Our ref: 51117-LT01-A
Your ref: MCU/2026/222
Contact: Alex Williams

Response to Council Information Request – Application Number MCU/2026/222
Proposed Mixed Use Development – 60 Kortum Drive, Burleigh Heads

60 KORTUM DRIVE, BURLEIGH HEADS
PROPOSED MIXED USE DEVELOPMENT

SWEPT PATH ASSESSMENT
B85 PASSENGER VEHICLE
ENTRY INTO PARKING BAY

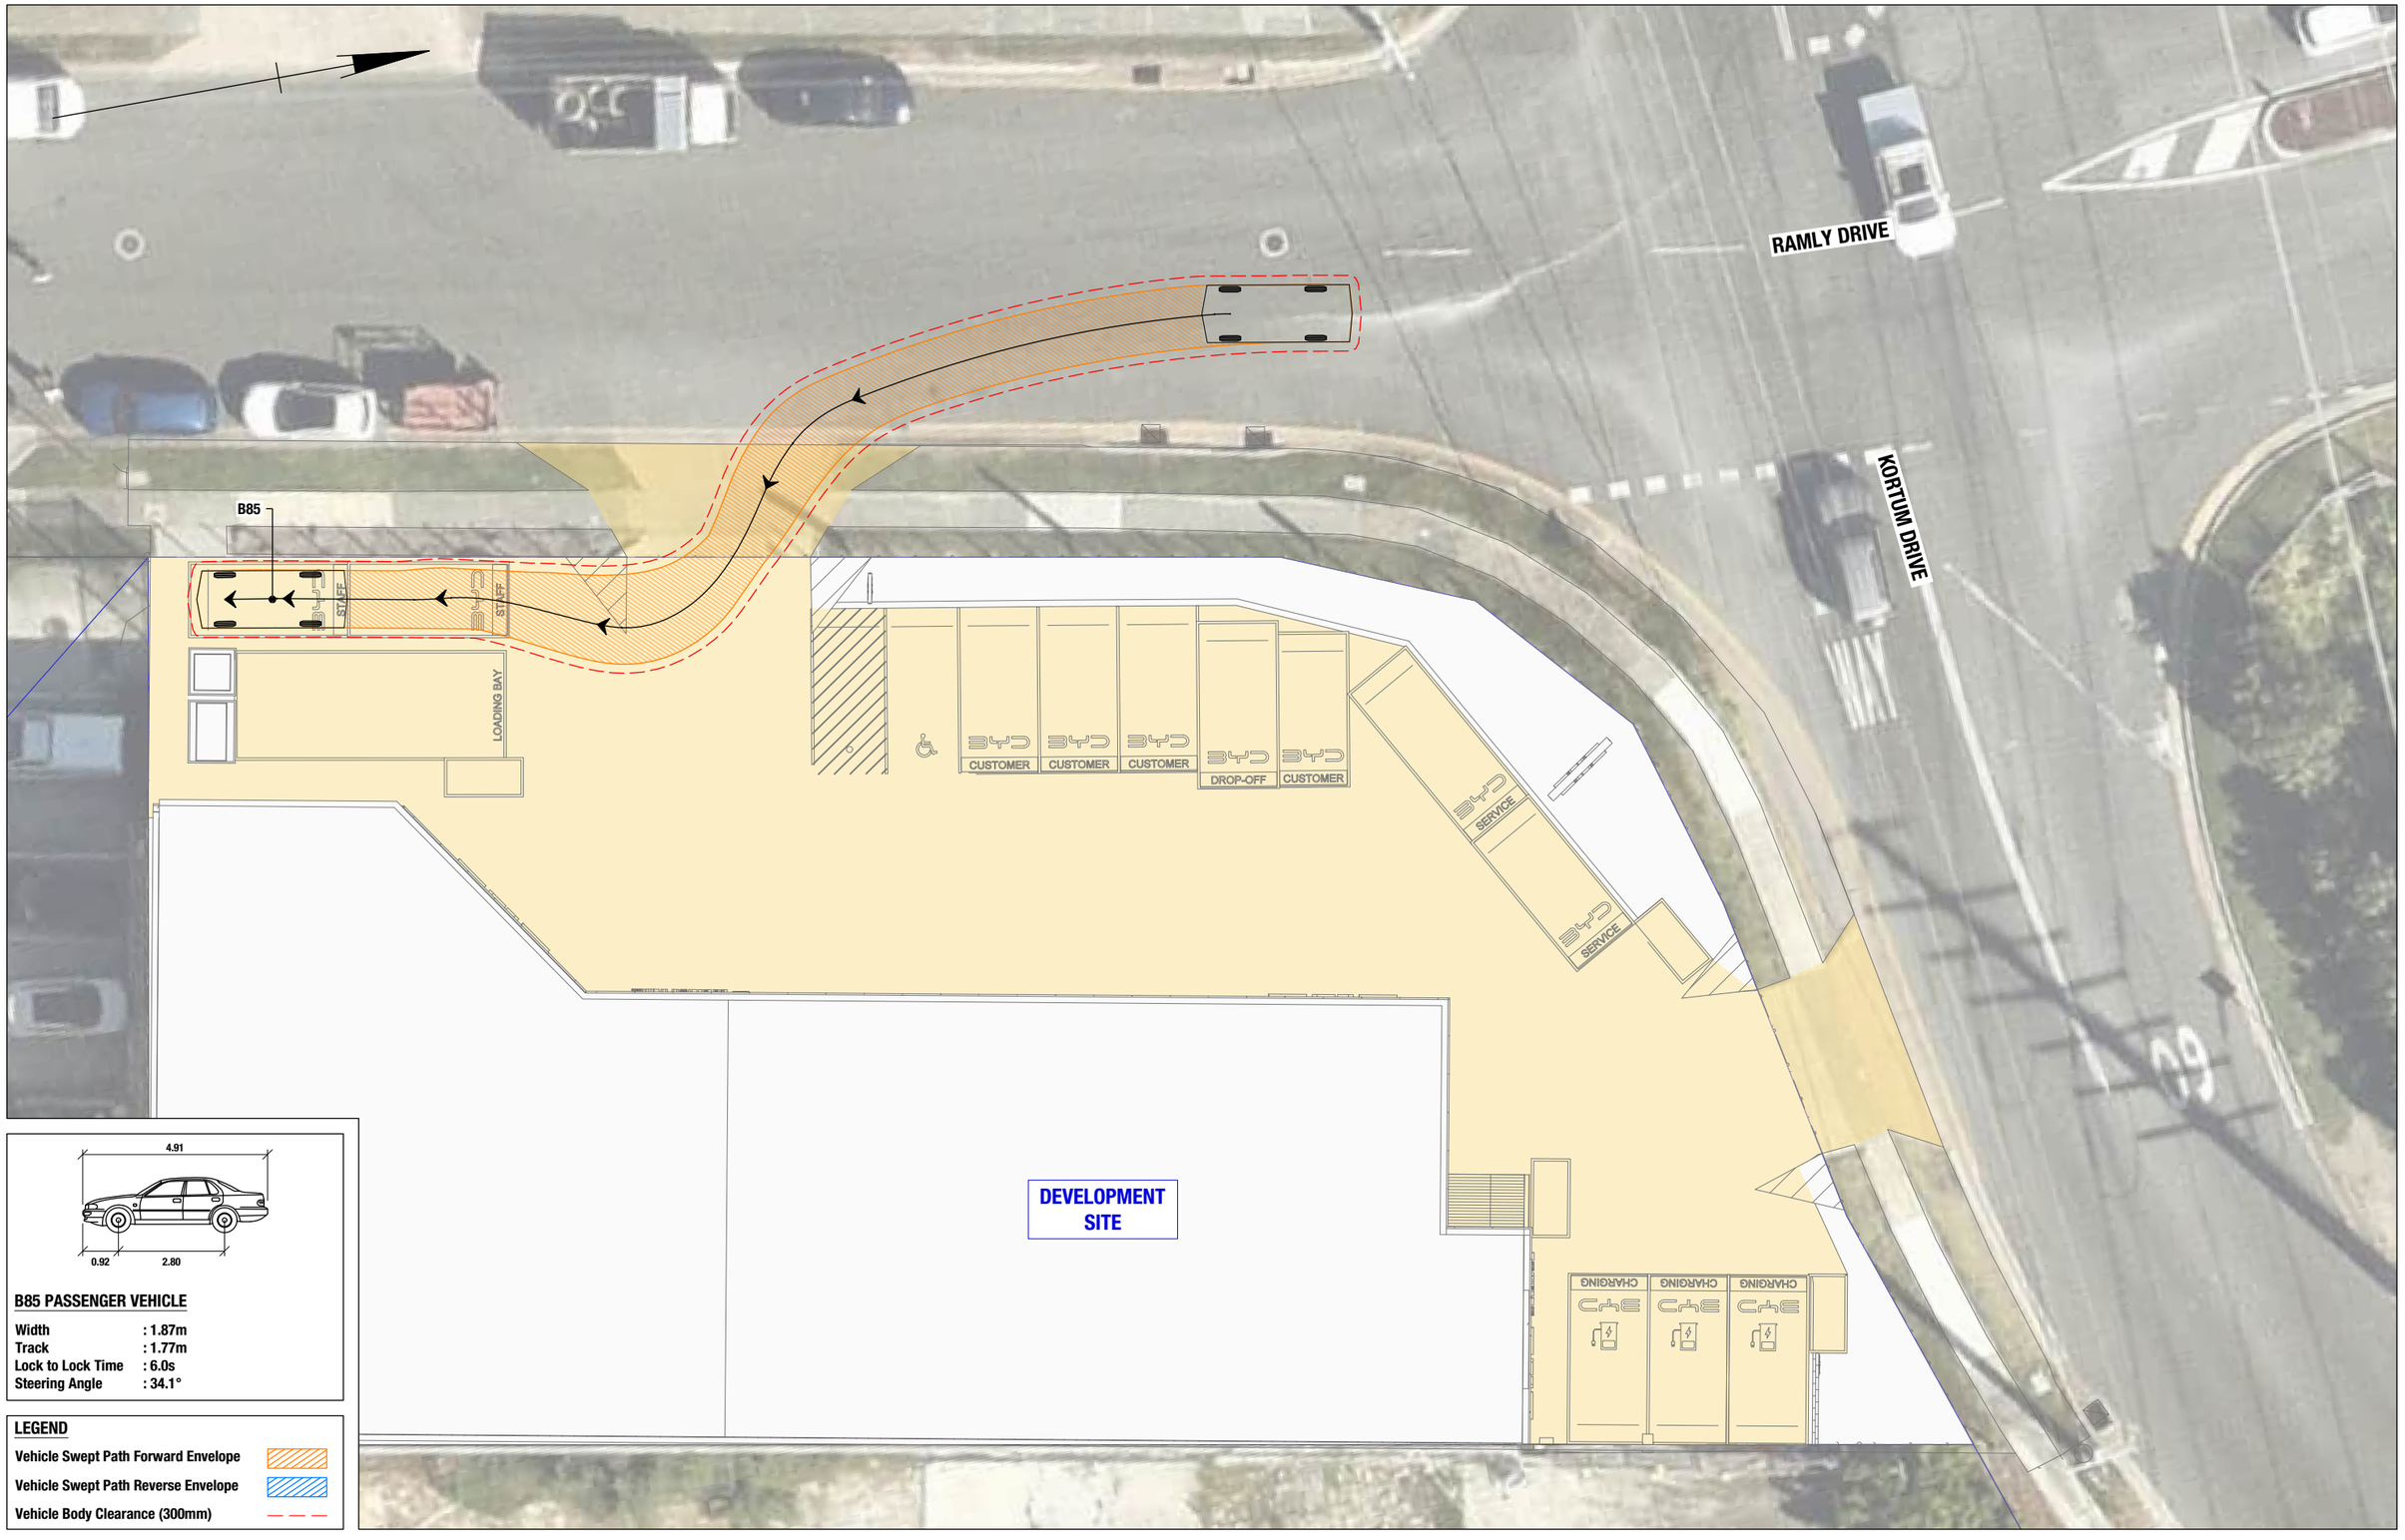
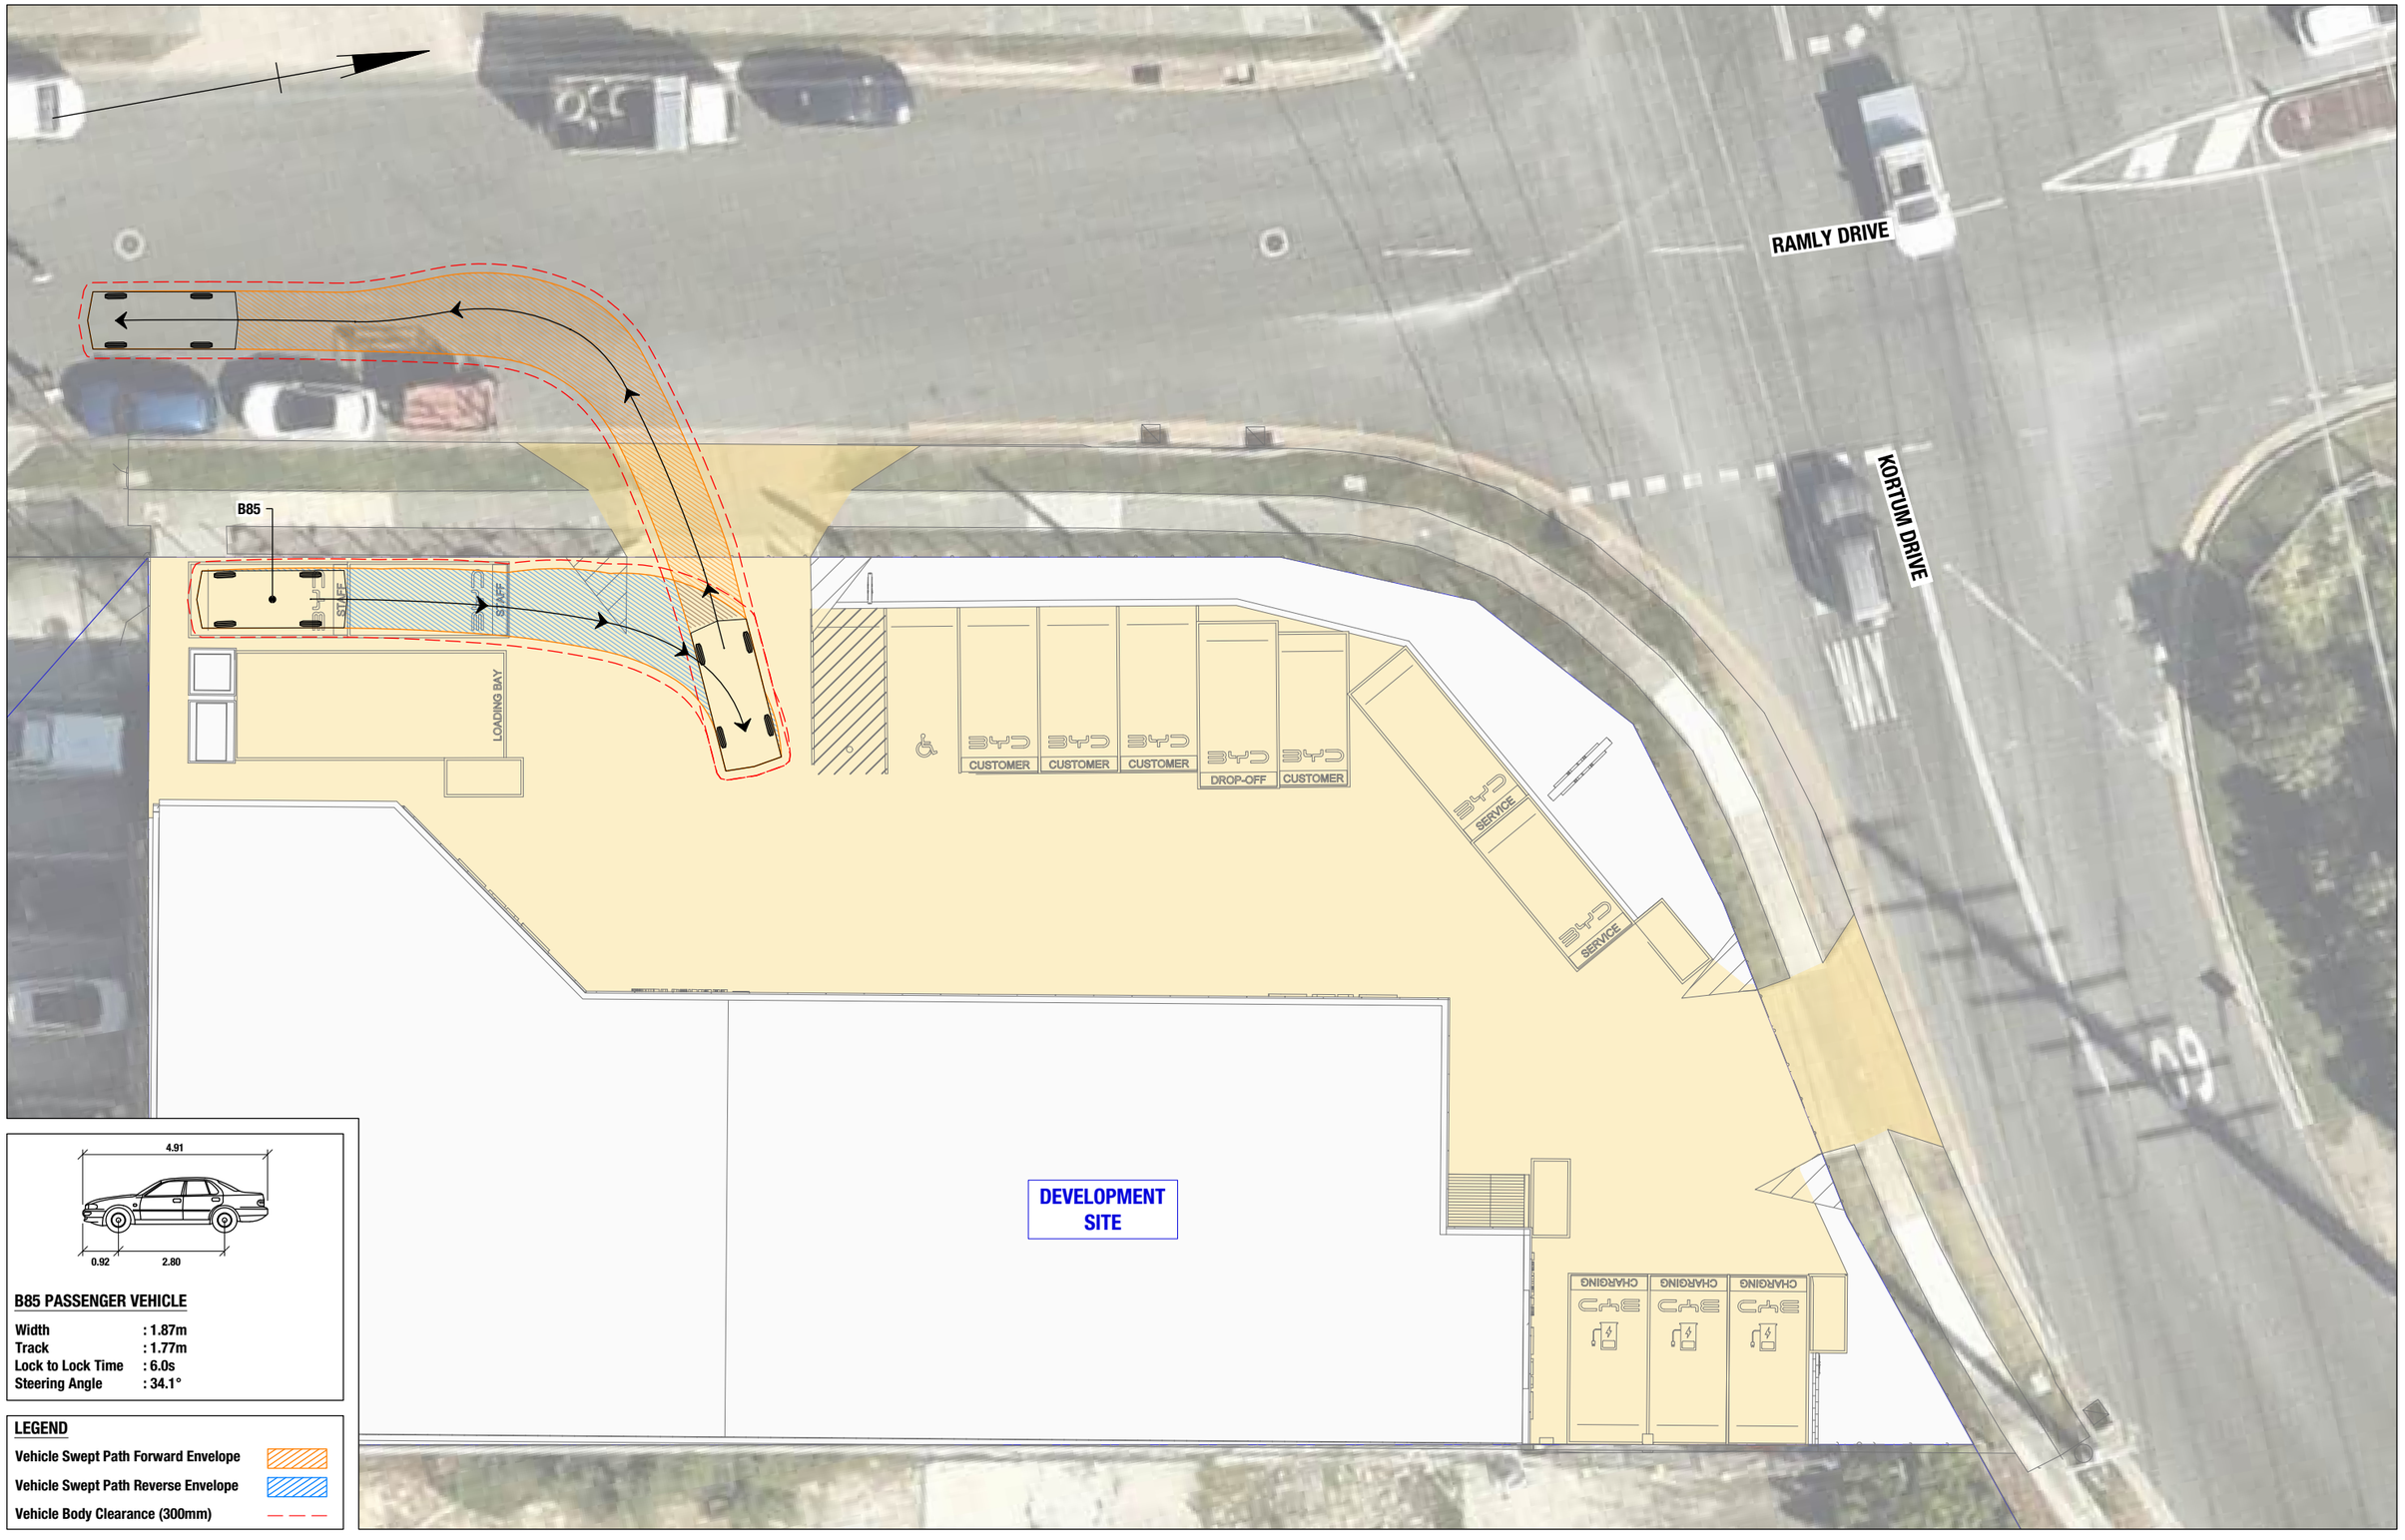
Based on review of the submitted drawings, officers have identified that the aisle width behind car parking bays 12-14 is insufficient. To comply with AO19.1 of the Transport code, the applicant is requested to submit amended drawings providing an alternative outcome which can achieve compliant aisle width. Note that this may require the applicant to consider an alternative layout.

Updated plans of development, included in **Attachment B**, illustrate the proposed on-site parking provision. Swept path analysis using AutoTURN software has been completed demonstrating the functionality of proposed parallel parking bay 8 and is included in **Attachment C**.
